# TECHNICAL BULLETIN

## Automatic Transmission – Engine Stalls When Engaging “R” or “D” – Repair Procedure

**44-23**

MODEL All 4.0L with Auto Trans

ILLUSTRATION 1

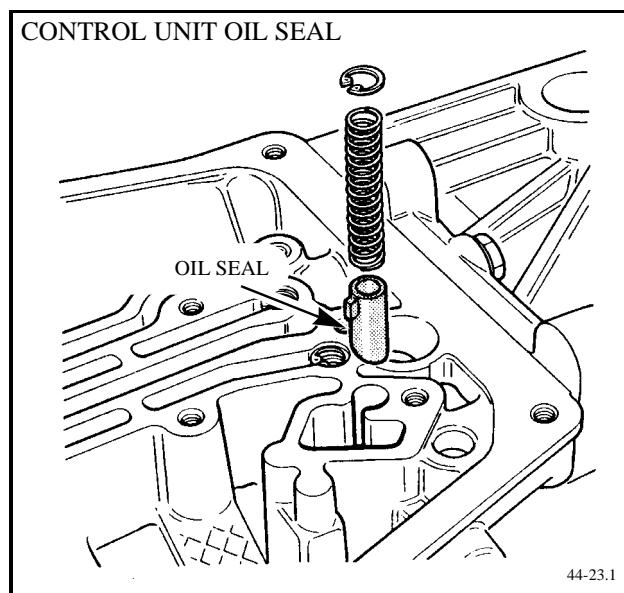
1. Remove the transmission valve body following the instructions in the Service Manual, section 44.2 (R.O. number 44.40.01).
2. Remove the control unit oil seal (part number JLM 863) shown in Illustration 1.

**CAUTION:** If the seal is incorrectly fitted or restricted, the lockup clutch may partially engage causing the engine to stall.

3. Install a new control unit oil seal
4. Reassemble the transmission following the instructions in the Service Manual.

ILLUSTRATION 2

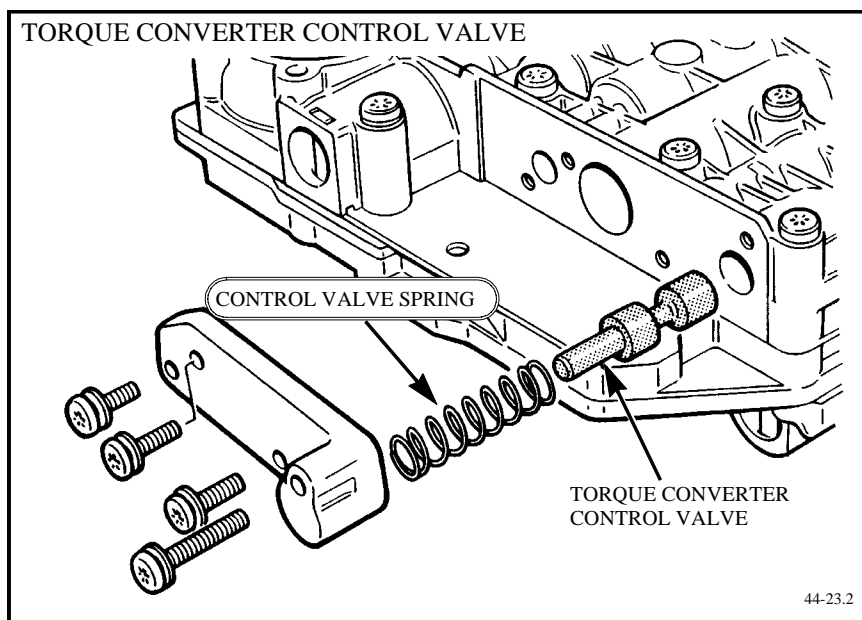
1. Remove the transmission valve body following the instructions in the Service Manual, section 44.2 (R.O. number 44.40.01).
2. Remove the torque converter control valve from the valve body (Illustration 2).

3. Clean the valve and valve bore. The valve must slide freely in the bore.
4. Refit the control valve using a new spring (part number JLM 11573).
5. Install the valve body.

**NOTE:** Torque the valve body securing screws to 6 lb ft (8 Nm).
